# DOCUMENT - 2024-149P Second Floor Expansion, 3190 Mavis Road, City of Mississauga, Project 22701

#### **ADDENDUM 2**

Interior photo: from Ex. Transhelp open offices- Room 109 (new column location at GL 11x and F)

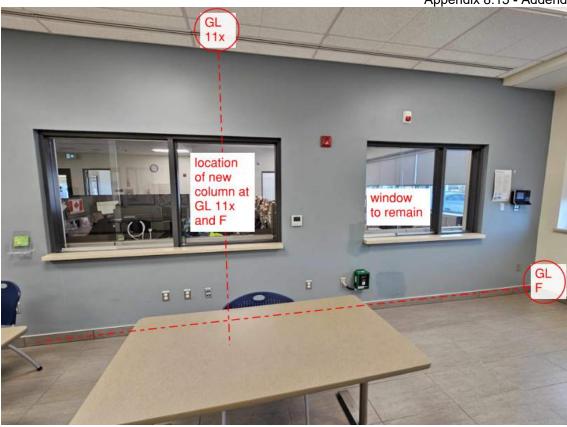
Request for site visit to access the existing building to locate where are the location of the new columns at the ground level and to know site accessibility if we need to create enclosure around the work areas?

Site visit cannot be arranged. Sufficient information has been provided in the Specification and Contract Drawings supported by site photographs. Additional photographs showing the building interiors are attached at Appendix 8.15 – Addendum 2, Additional Existing Site Photos-3190 Mavis Road, Project 22701.
